St. Pancras Cruising Club

Application No: 2016/0289/C

Proposal: Details of works to the Regent's Canal walls associated with the formation of Camley Bridge, etc.

Camley Bridge
Reserved Matters Submission

Boundary Fences

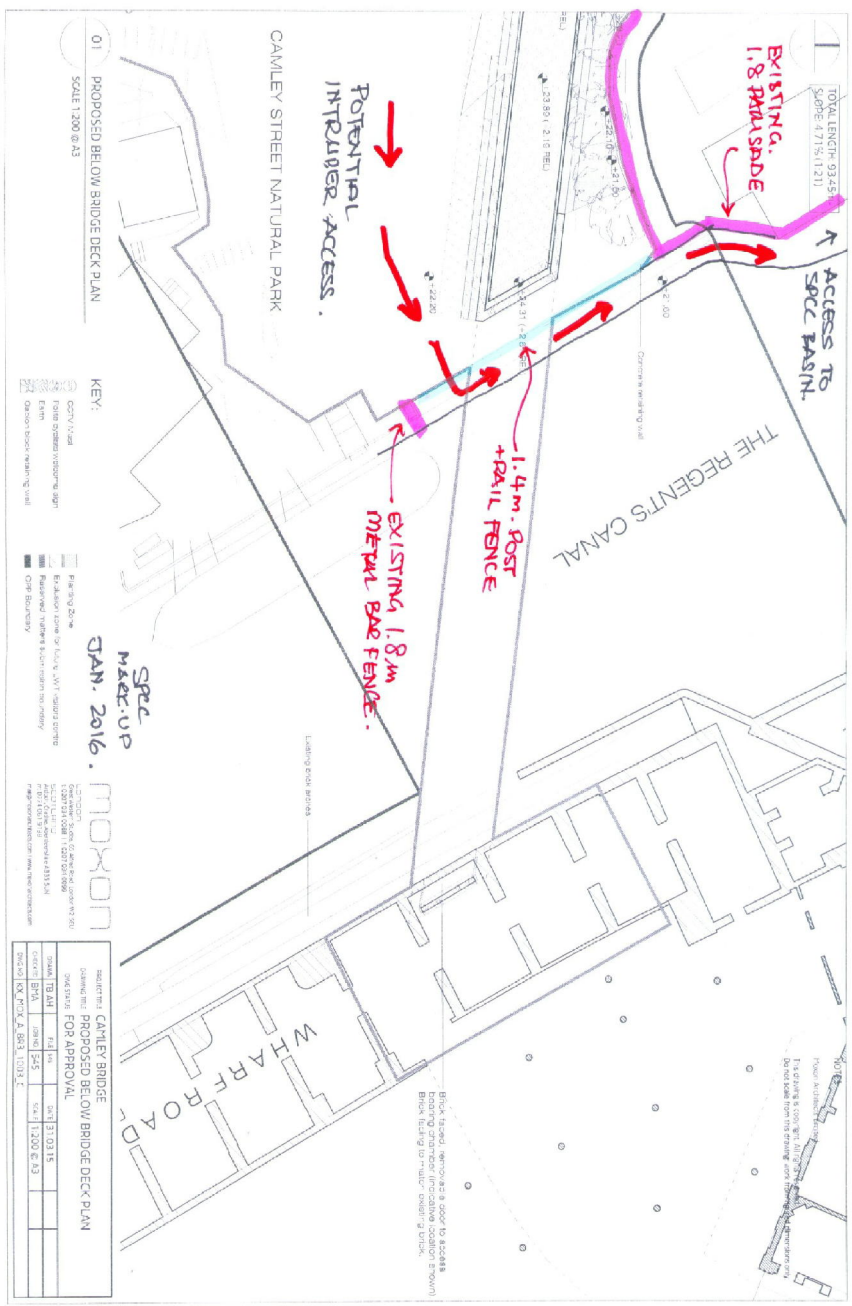
Whilst the proposed fence on the northern boundary is 2.2 m compared to the existing 1.8 m fence, it is proposed to be a chain link wire fence on timber posts against the current heavy timber post 'stockade' backed with extensive planting. Such a considerably lighter construction will require good and frequent inspection and maintenance to retain it in a secure condition

The description of the Camley Street boundary treatment as visually more permeable also reinforces that the proposals will open up to view areas that are currently only glimpsed through gaps in fences and hedging.

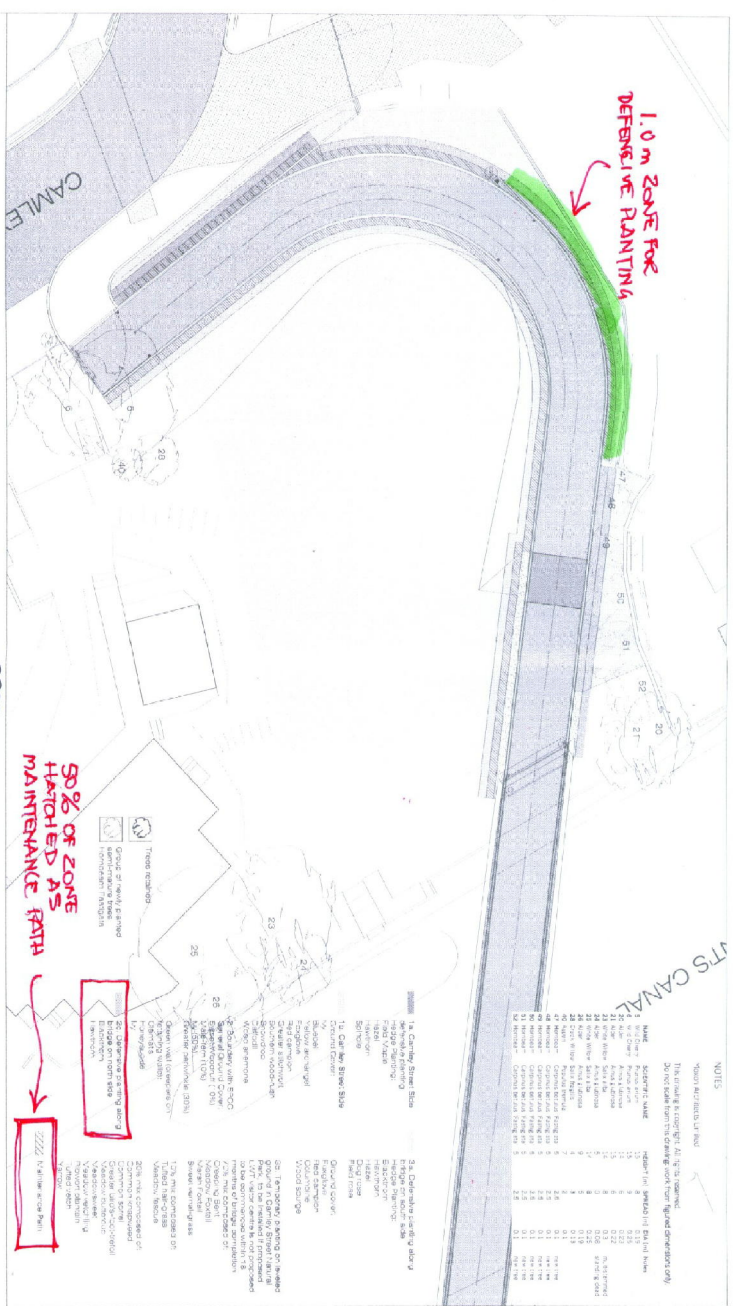
Drawing BR3_1014_F of the Drawing package shows defensive planting between the bridge ramp and the SPCC boundary fence as a 1.0 m wide strip beside the bridge, this is then part over-hatched to indicate a 500 mm maintenance strip leaving only 500 mm for the actual planting zone. *(This drawing is reproduced as the third of the marked up plans appended to this document.)* This would appear inadequate to provide space for the proposed Hawthorn and Blackthorn hedging to achieve a size to be effective as defensive planting.
